APPLICATION BY
CITY OF GRANBURY,
FOR TPDES PERMIT NO.
WQ0015821001

EXHIBIT GF-304

Attachment DAR 1.1-3
Buffer Zone Map
&
Temporary EQ Basin Buffer Zone Justification

GRANBURY EAST WASTEWATER TREATMENT PLANT
 CITY OF GRANBURY,
 HOOD COUNTY, TEXAS

BUFFER ZONE MAP
 INTERIM PHASE (PAGE 2)

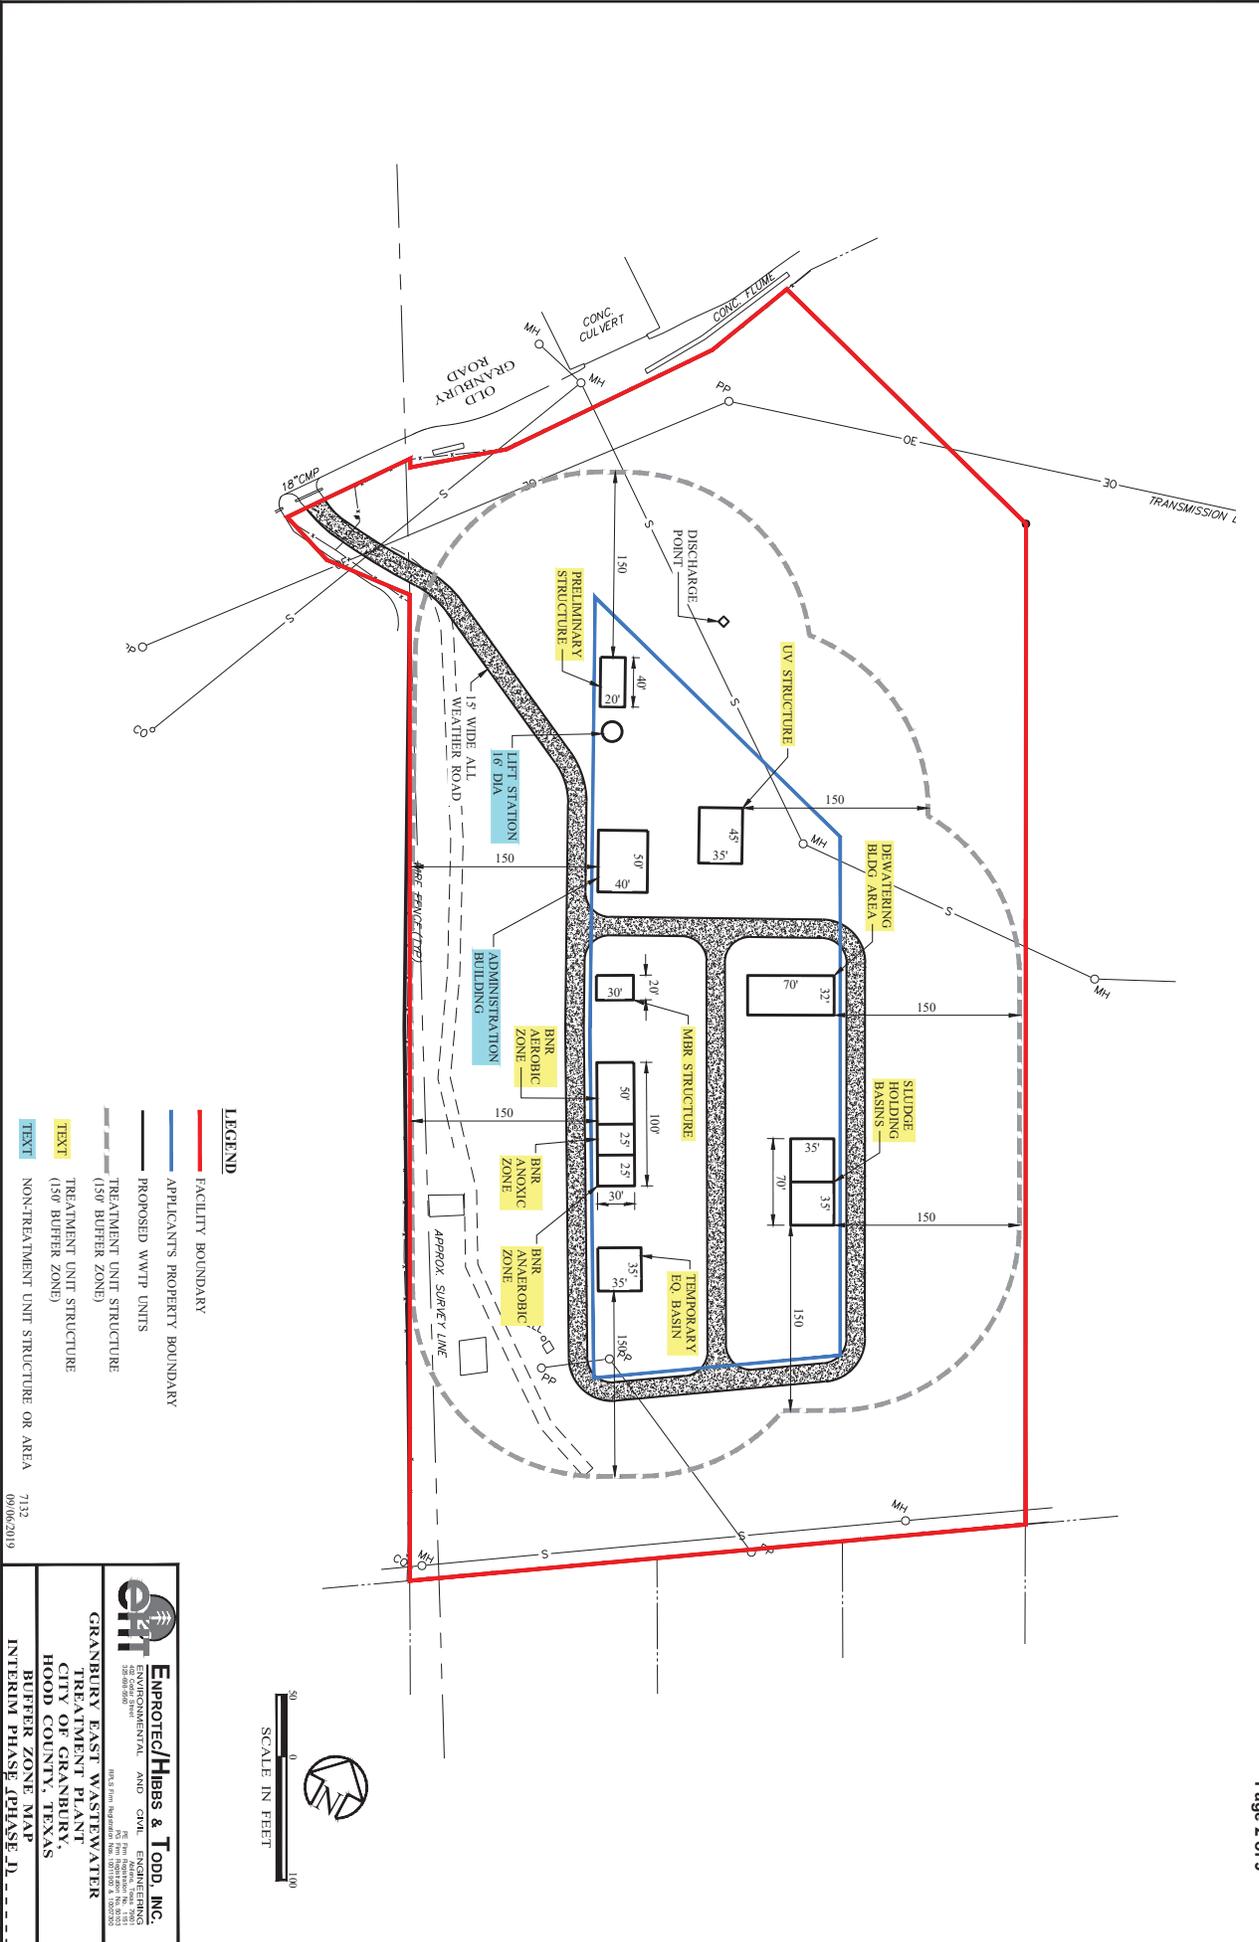
A 150-foot buffer zone is applicable for the temporary EQ basin since the wastewater will not be allowed to remain in the temporary EQ basin for more than 48 hours. See the attached emails related to the Cisco WWTP between eHT and TCEQ (Louis Herrin) with additional clarifications.

A 150-foot buffer zone is applicable for the proposed treatment units since no units will be allowed to “go septic”. The proposed WWTP treatment system at the East WWTP will be similar to the proposed improvements at the existing Granbury South WWTP (WQ0010178002). Per Josh Berryhill, PE, eHT Technical Director and Project Design Engineer, the buffer zone justification emails between eHT and TCEQ (Gordon Cooper) related to the Granbury South WWTP minor amendment application (WQ0010178002) are applicable to the proposed Granbury East WWTP. See the attached Granbury South WWTP buffer zone emails.

We discussed this with Louis Herrin and the question has come up whether the system is designed to be or is it going to be allowed to go septic in the anoxic or anaerobic basins. If not the 150-foot buffer zone is OK, if it is then the buffer zone would need to be 500 feet for the anaerobic and anoxic basins.

The question about the buffer zone in my previous e-mail also applies to the BNR system in the proposed improvements, with regard to the anaerobic and anoxic basins. Please also provide additional information as to how the facility will meet the buffer zone requirements located in 30 TAC §309.13(e).

A question has come up about the buffer zone with regard to any anaerobic activity at the City of Granbury WWTP. Diagram sheet No. 00G-11 and sheet No. 00G-12 indicate that Aeration Basins 1 & 2 will become Equalization Basins 1 & 2. Please note that rules located in 30 TAC §309.13(e)(1) state that "lagoons with zones of anaerobic activity (e.g., facultative lagoons, un-aerated equalization basins, etc.) may not be closer than 500 feet to the nearest property line." When Aeration Basins 1 & 2 become Equalization Basins 1 & 2 with the proposed improvements, will these Equalization Basins remain aerated enough to meet the requirements for a 150-foot buffer zone, or if they are not going to be aerated and be considered anaerobic, please provide information as to how the facility will meet the 500-foot requirements located in 30 TAC §309.13(e)(1).

The proposed Granbury East WWTP will utilize a temporary equalization (EQ) basin, as needed, and will utilize biological nutrient removal (BNR) anaerobic, anoxic, and aeration basins upstream of the membrane bioreactor (MBR) basins.

The anoxic selector zone will always have oxygen in the zone, though only in the form of bound oxygen. By maintaining only bound oxygen in the anoxic selector, we can promote denitrification in the anoxic selector, maintaining an ORP value of 50 to -50 mV. The anoxic selector will not be allowed to go septic.

For the anaerobic selector, we will be mixing (via submerged mixers to minimize water surface disturbance) denitrified mixed liquor with influent wastewater from the collection system (following appropriate screening and grit removal). While we want to maintain a slightly negative ORP to allow for phosphorus conversion to a form assimilable for biological uptake in the aerobic selector zone, our goal is to stay right at the bottom edge of the ORP range for anoxic denitrification (-50 to -100 mV), in order to prevent the anaerobic selector from going septic, which would be expected to occur for an ORP of -100 to -25 mV.

The BNR system only needs the 150-foot buffer zone, as proposed in the application. See the details provided in the email below from Josh Berryhill, the project design engineer and eHT's Technical Director (email on Thursday, May 02, 2019 2:53 PM).

With regard to your inquiry on the EQ basins, Josh emailed me the following on Mon 4/29/2019 8:58 AM, "This issue is the same as when we discussed this with Louis Herrin on the Cisco project. The EQ basins will store water only during a major storm event, whereas influent will be drained back to the head of the plant for treatment as soon as the storm event subsides. Furthermore, beyond what we proposed in Cisco, the EQ basins at Granbury will be covered, with foul air drawn off and treated biologically.

For these reasons, the EQ basins should not be considered in the same category as anaerobic treatment lagoons." See the attached referenced email on the Cisco WWTP project. Therefore, the 150-foot buffer zone is applicable for the EQ basins, as proposed in the application.

Both the anaerobic and anoxic basins will utilize submersible mixers that allow mixing of the influent flow with an internal mixed liquor recycle stream that minimizes surface turbulence and production of H₂S. Furthermore, the internal recycle stream to the anoxic zone consists of bound oxygen (in the form of NO₃) that eliminates any H₂S formation in the anoxic zone. It is common with BNR processes to not require covers or odor control for anaerobic or anoxic zones, as they do not off gas like primary clarifiers or anaerobic digesters.

Per Josh Berryhill, P.E., with eHT on Wednesday, September 11, 2019, at 8:30 am, the information contained within this email is applicable to the proposed Granbury East WWTP temporary EQ basin. The temporary EQ basin proposed for the Granbury East WWTP will empty within 48 hours of use.
